Special Council Meeting

13 June 2018

Form 1 - Responsible Authority Report
(Regulation 12)

Property Location:	Lots 29-31 (Nos 50-52) Melville Parade, South Perth
Development Description:	31 Level (103.1m) Mixed Use Development
DAP Name:	Metro Central JDAP
Applicant:	Hillam Architects
Owner:	NL Homes Melville Pty Ltd
Value of Development:	\$85 Million
LG Reference:	11.2017.326.1
Responsible Authority:	City of South Perth
Authorising Officer:	Vicki Lummer – Director Development and Community Services Stevan Rodic – Manager of Development Services Brendan Philipps –Statutory Planning Officer
DAP File No:	DAP/17/01288
Report Due Date:	8 June 2018
Application Received Date:	22 September 2017
Application Process Days:	90 Days (plus extension / stop-the-clock / deferral)
Attachment(s):	1. Revised and Latest Development Plans (latest revisions dated 4 May 2018): A2-00 through A2-19 and A3-01 through A3-04 2. Applicant's Supporting Documents and Reports 3. Previous RAR dated 9 February 2018

5.4 SHADOWS ON 22ND DECEMBER - COMPARISON

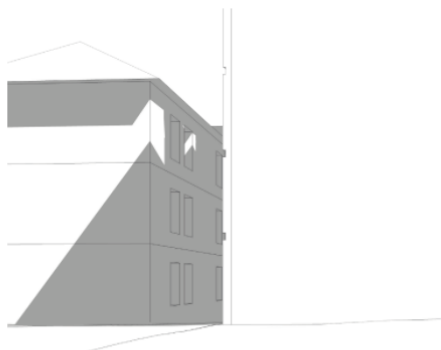
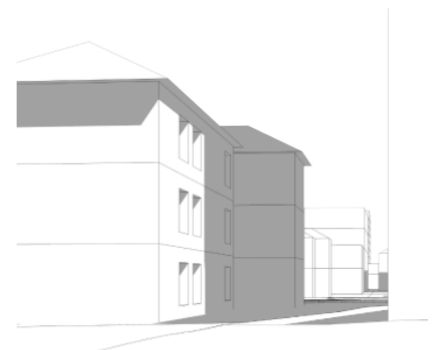
Further to the above, in reviewing the impact to the east, it is recognised the southern-most portion of the western elevation of the building at 3 Bowman Street has a blank wall, which is where the predominant extent of shadow would be cast from the proposed development. It is also noted that the revised proposal is adjusting the podium height to below the allowable limit of 13.5m specified in Schedule 9A specifically to reduce the impact on the neighbouring properties and to accommodate a more sensitive design compared with the previous scheme.

4.1 SETBACK - SECTIONAL COMPARISON

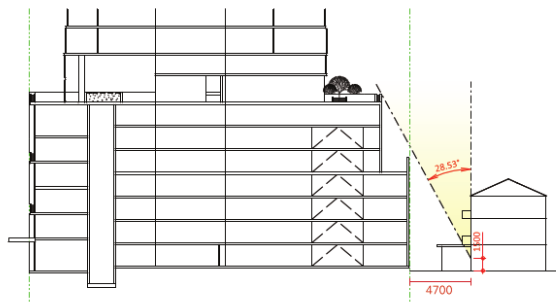
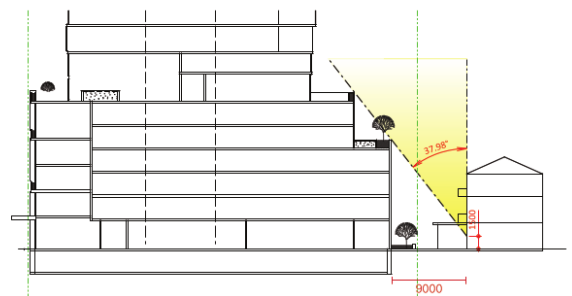
- 1. The potential to make modifications to the podium on the eastern side of the property, such as to significantly reduce its impact on the adjoining property. Such consideration could involve a reduction in the height and scale of the podium and setback from Bowman Street and inclusion of an underground parking component that would reduce the need for a podium of the nature proposed.*
- 2. The modification of the existing wind impact assessment to include the specific assessment of the impact on the adjoining properties.*

The lower podium has been setback and then reduced to 13m to improve sightlines and amenity of 3 Bowman Street.
